ENGINE - OIL - INTRODUCE A NEW OIL PRESSURE PUMP OUTLET-TO-ACOC TUBE SEALING RING -  
CATEGORY CODE 5 - MOD.ENG-79-0039

**V2500-ENG-79-0039**

Location of Pressure Oil Tube (A1 Engines of PRE-SBE 71-0110 standard)  
Fig.1 (Sheet 1 of 3)

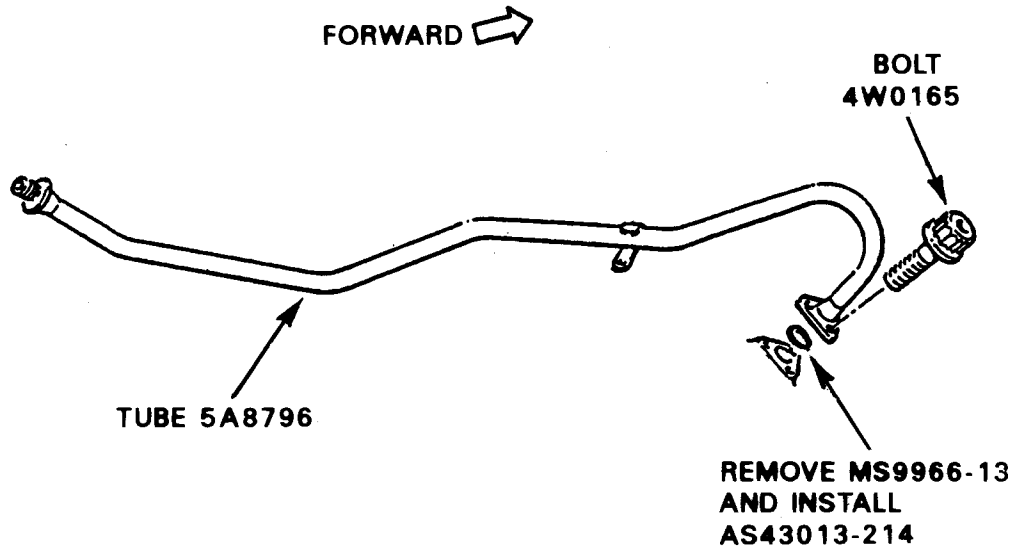
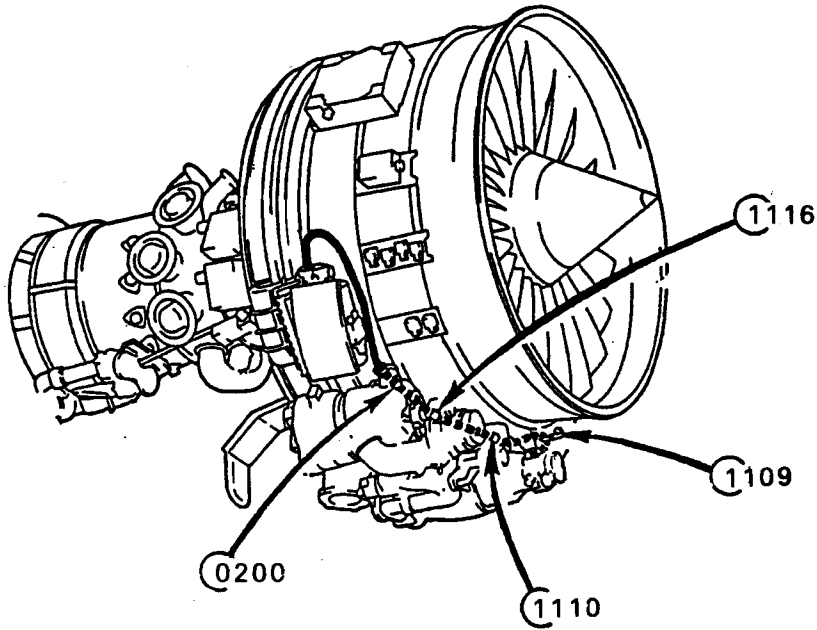
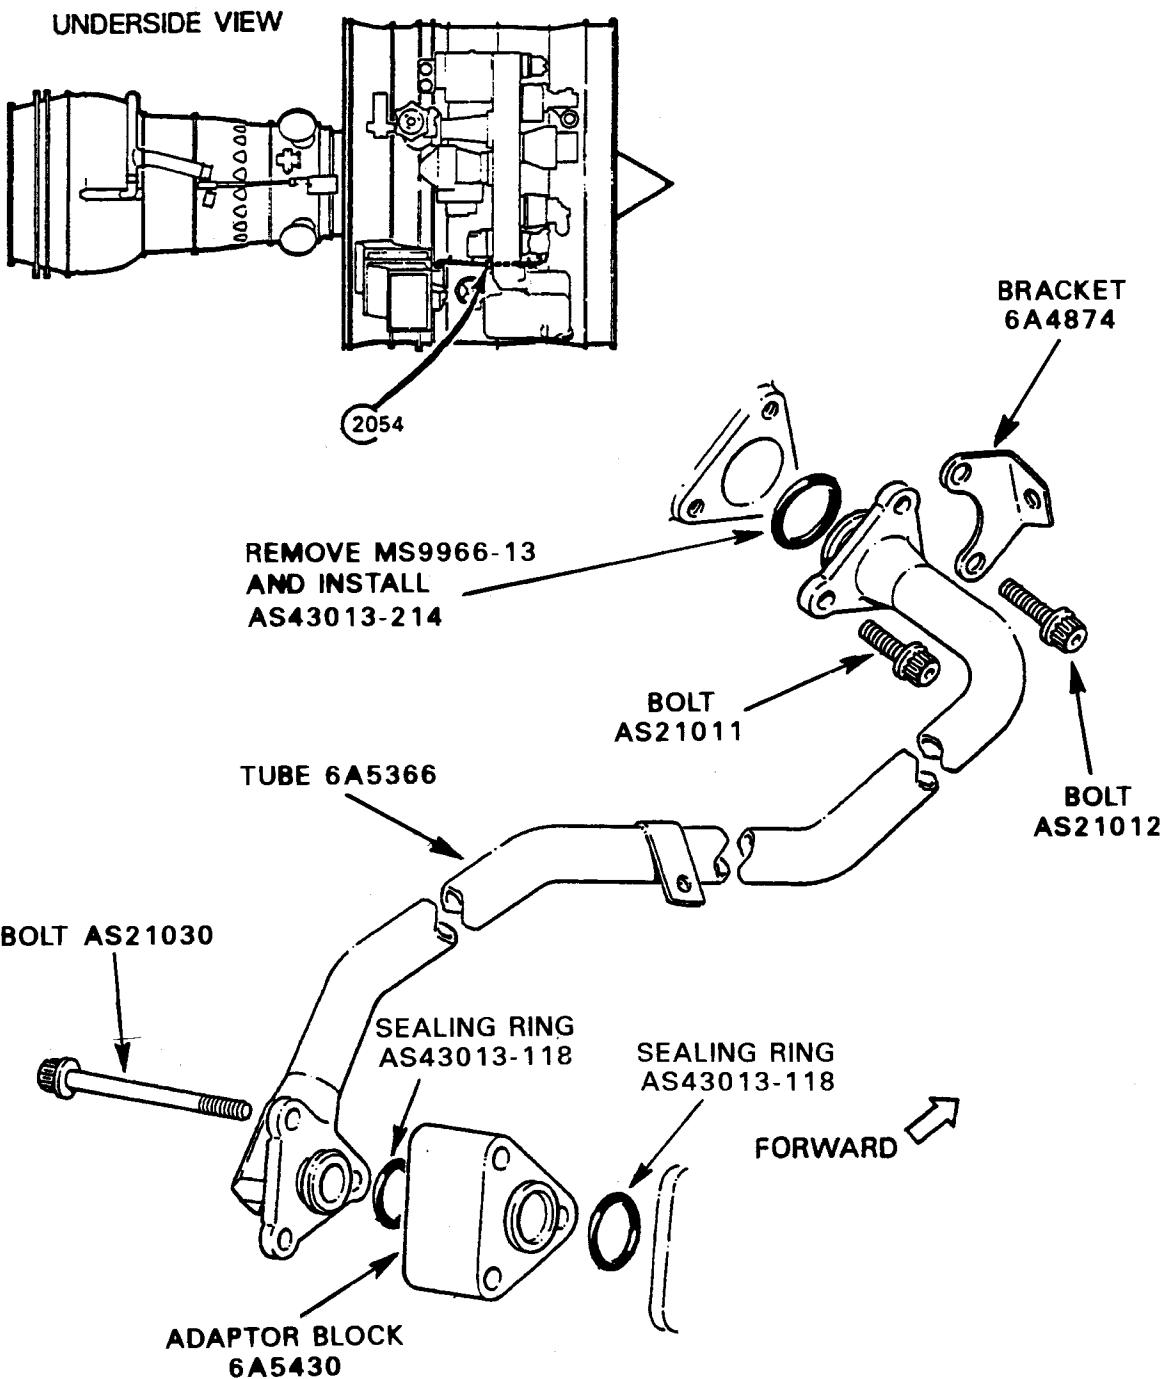
- (1) For V2500-A1 Engines not incorporating SBE 71-0110.
- (a) Find the 5A9187 or 5A8786 oil tube. Refer to Figure 1.
  - (b) Remove the 4W0165 bolts (3 off) that attach the 5A9187 or 5A8786 oil tube to the oil pump. Remove the tube and retain the 4W0165 bolts. Refer to Figures 1, 2 and 3.

- (a) Find 5A8796 oil tube. Refer to Figure 1.
  - (b) Remove the 4W0165 bolts (3 off) that attach the 5A8796 oil tube to the oil pump. Remove the tube and retain the 4W0165 bolts. Refer to Figures 1, 2 and 3.

- (e) Remove the MS9966-13 preformed packing from the 5A8796 oil tube. Refer to Figure 4.
- (3) For V2527-A5 and V2530-A5 Engines
- (a) Find 5A8796 oil tube. Refer to Figure 1.

- (4) For V2525-D5 and V2528-D5 Engines
- (a) Find 6A5366 oil tube. Refer to Figure 1.
  - (b) Remove the AS21011 bolt (1 off), AS21012 bolts (2 off) and 6A4874 bracket that attach the 6A5366 oil tube to the oil pump. Remove the tube and retain the parts. Refer to Figures 1, 2 and 3.

View at AC  
Fig.2

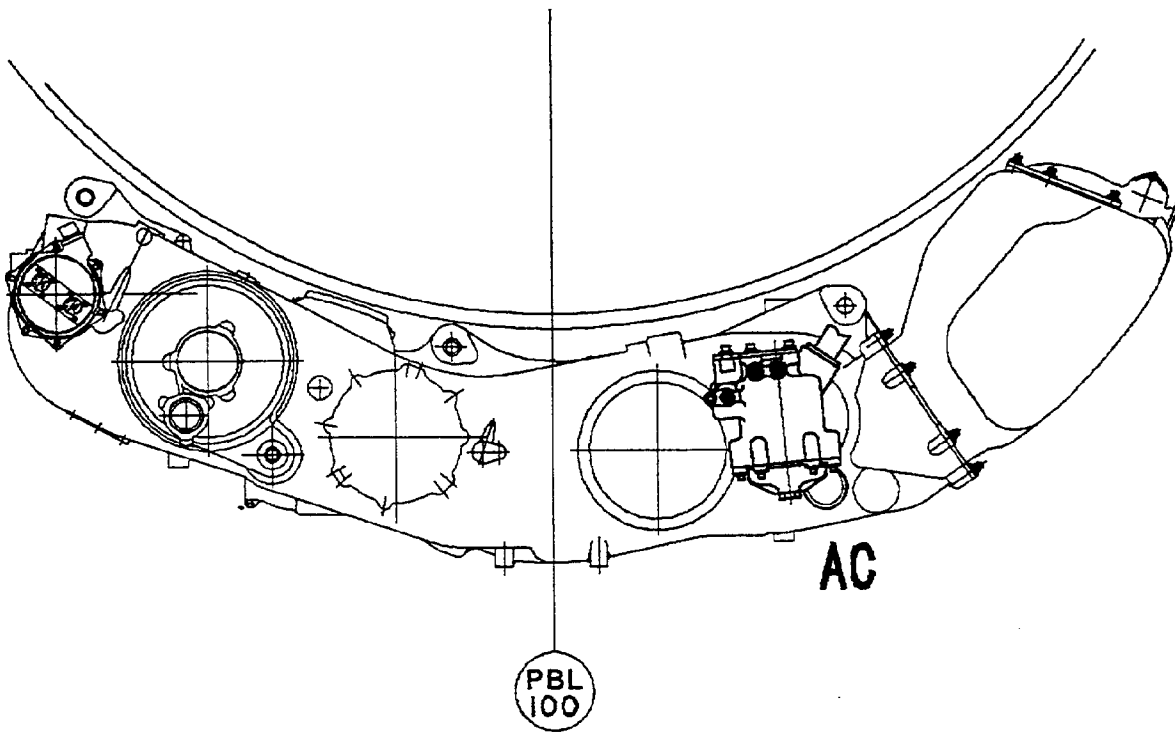
- (b) Remove the 4W0165 bolts (3 off) that attach the 5A8796 oil tube to the oil pump. Remove the tube and retain the 4W0165 bolts. Refer to Figures 1, 2 and 3.

Enlarged view at AC showing Filter Housing Outlet  
Fig.3

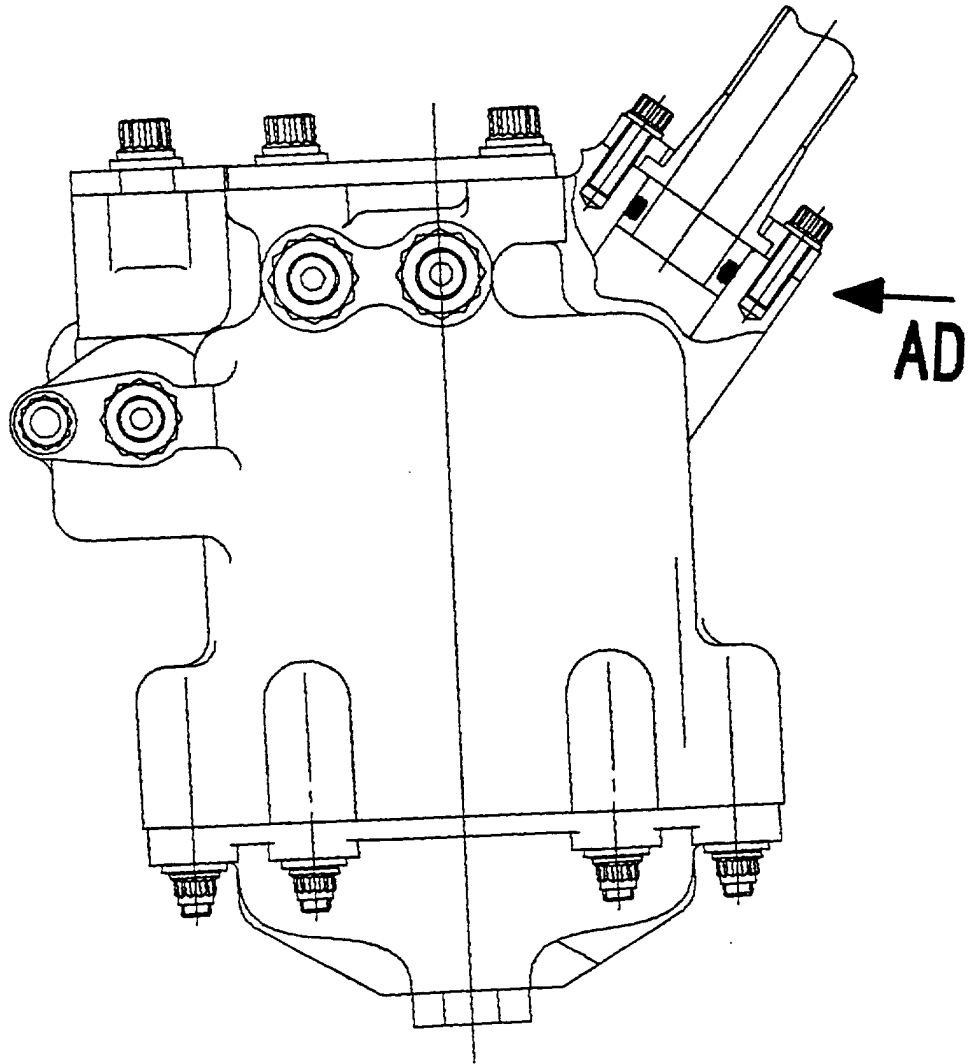
Static oil leakage from the oil pressure pump and filter casing outlet.

Instances of static oil leakage from the pressure pump and filter casing have occurred in service. On inspection the preformed packing appeared deformed.

Enlarged view at AD showing Oil Sealing Ring - Before and after alteration  
Fig.4

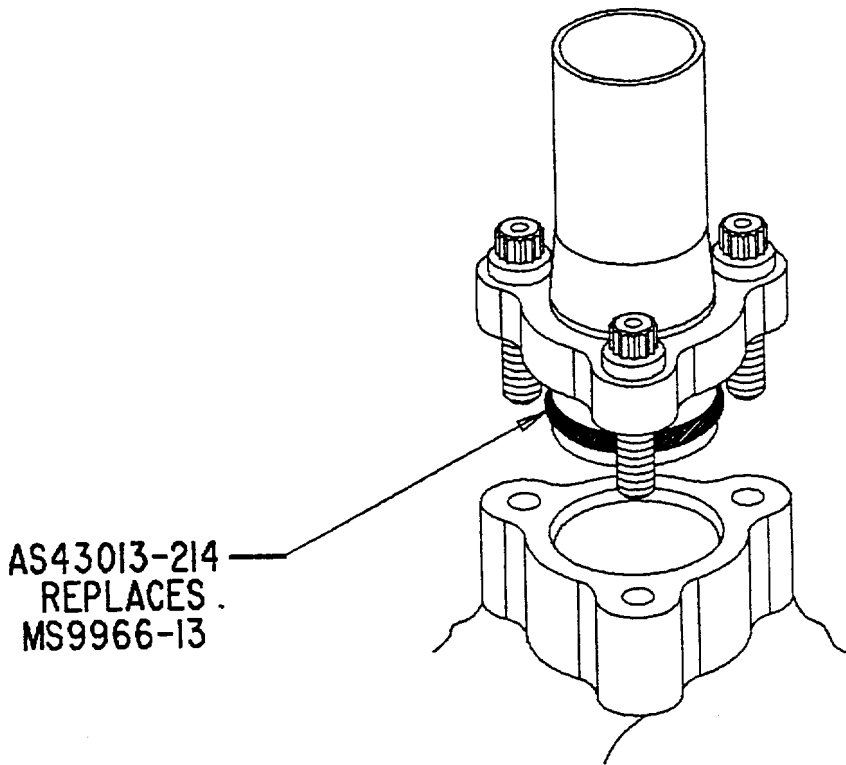
- (1) A redesigned sealing ring with a better fit and improved material.

- (e) Remove the MS9966-13 preformed packing from the 5A9187 or 5A8786 oil tube. Refer to Figure 4.
- (2) For V2500-A1 Engines incorporating SBE 71-0110

- (d) Disassemble clipping points CP1109, CP1110, CP1116 and CP0200 sufficiently to allow movement of 5A8796 oil tube, retain all parts.
  - (e) Remove the MS9966-13 preformed packing from the 5A8796 oil tube. Refer to Figure 4.

- (1) For V2500-A1 Engines not incorporating SBE 71-0110.
  - (a) Lubricate a new AS43013-214 sealing ring with CoMat 10-077 approved engine oils and install the sealing ring to the 5A9187 or 5A8786 oil tube.
  - (b) Using the 4W0165 bolts (3 off) removed in step A.(1)(b) install the 5A9187 or 5A8786 oil tube to the oil pump. Torque the bolts to 85 to 105 lbfin (10 to 12 Nm).
  - (c) Connect the 5A9187 or 5A8786 oil tube union to the 5A8773 oil tube and torque the nut to 478 to 513 lbfin (54 to 58 Nm).
  - (d) At existing clipping points CP0200, CP0331 and CP0334 secure the 5A9187 or 5A8786 oil tube using the parts removed in step A.(I)(d). Torque the bolts and nuts to 36 to 45 lbfin (4 to 5 Nm).
  - (e) Safety the oil tube union with CoMat 02-126 lockwire.

- (2) For V2500-A1 Engines incorporating SBE 71-0110
- (a) Lubricate a new AS43013-214 sealing ring with CoMat 10-077 approved engine oils and install the sealing ring to the 5A8796 oil tube.

- (e) Safety the oil tube union with CoMat 02-126 lockwire.
- (3) For V2527-A5 and V2530-A5 engines
- (a) Lubricate a new AS43013-214 sealing ring with CoMat 10-077 approved engine oils and install the sealing ring to the 5A8796 oil tube.

- (e) Safety the oil tube union with CoMat 02-126 lockwire.
- (4) For V2525-D5 and V2528-D5 engines
- (a) Lubricate a new AS43013-214 sealing ring with CoMat 10-077 approved engine oils and install the sealing ring to the 6A5366 oil tube at the oil pump filter end location.
